**CAMPBELLTOWN
CITY COUNCIL**

LOCAL PLANNING PANEL

24 FEBRUARY 2021

| 4.1 | Construction of a single storey dwelling and associated works - 1 Denfield Circuit, St Helens Park | 6 |

Attachment 1

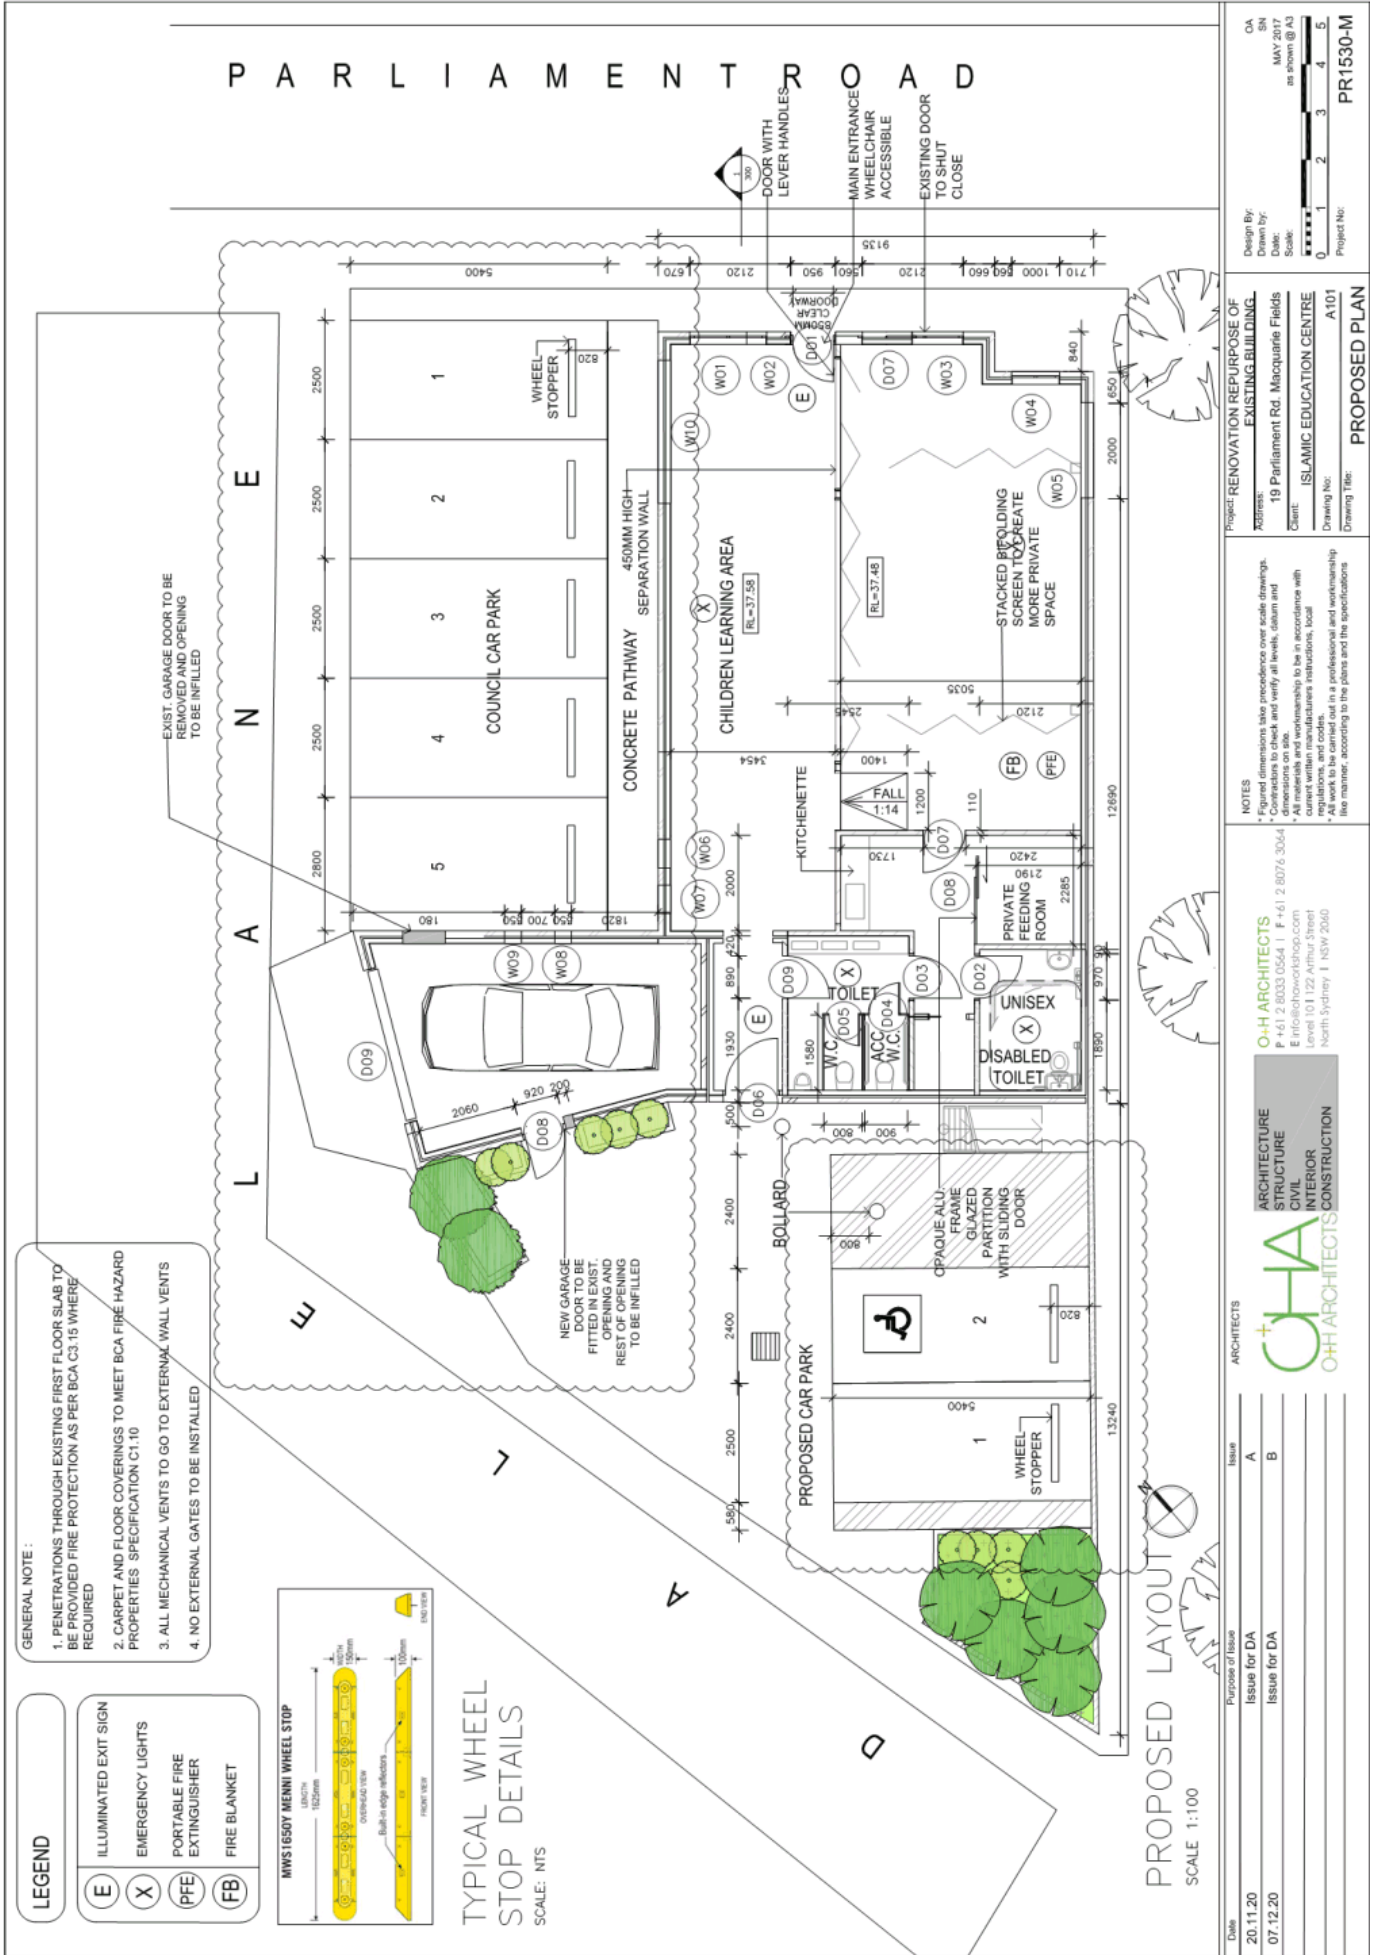
10. Proposed Plan DWG. A200 shows the placement of a bollard within the rear yard. Clarification of the location of this bollard is required to be submitted as the proposed location appears to conflict with traffic movements.

Swept path diagrams, provided as **Attachment 2**, demonstrated that vehicles parked in the two (2) car spaces do not impact or conflict with the proposed bollard when entering or exiting the site. The design provides a blind aisle extension beyond the accessible space well exceeding the minimum 1.0 metre required by Figure 2.3 of AS 2890.1, given the presence of the adjacent shared area. The bollard in question is well beyond the minimum 1.0 metre clearance, with swept paths demonstrating no conflict when entering or exiting the site.
